BULLETIN

CARLYLE COMPRESSOR DIVISION

Number: 03T-3

CARLYLE CE MARK COMPLIANCE

06E, 06CC – with 9-Terminals

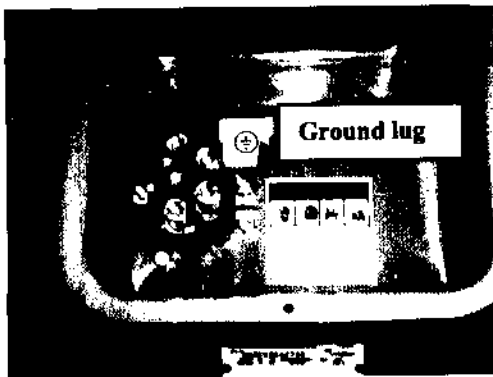
Carlyle is announcing that its 06D, 06E, 06CC & 06T compressors comply with the CE Mark requirements and will have the CE Mark logo added to the appropriate compressor nameplates. With the implementation of the CE Mark, a ground lug has been added to the terminal plate. For the location of the lug with the various compressor configurations – see the figures below. The CE Mark and ground lug will become effective in February of 2003 on all the compressors.

The terminal box grounding lug (Carlyle P/N HY90HR001) is a compression fitting with the capability of connecting a wire size in the #14 to #6 range. If the grounding lug is loosened to re-orientate the direction, it should be tightened to a torque of 18 to 28 in-lbs.
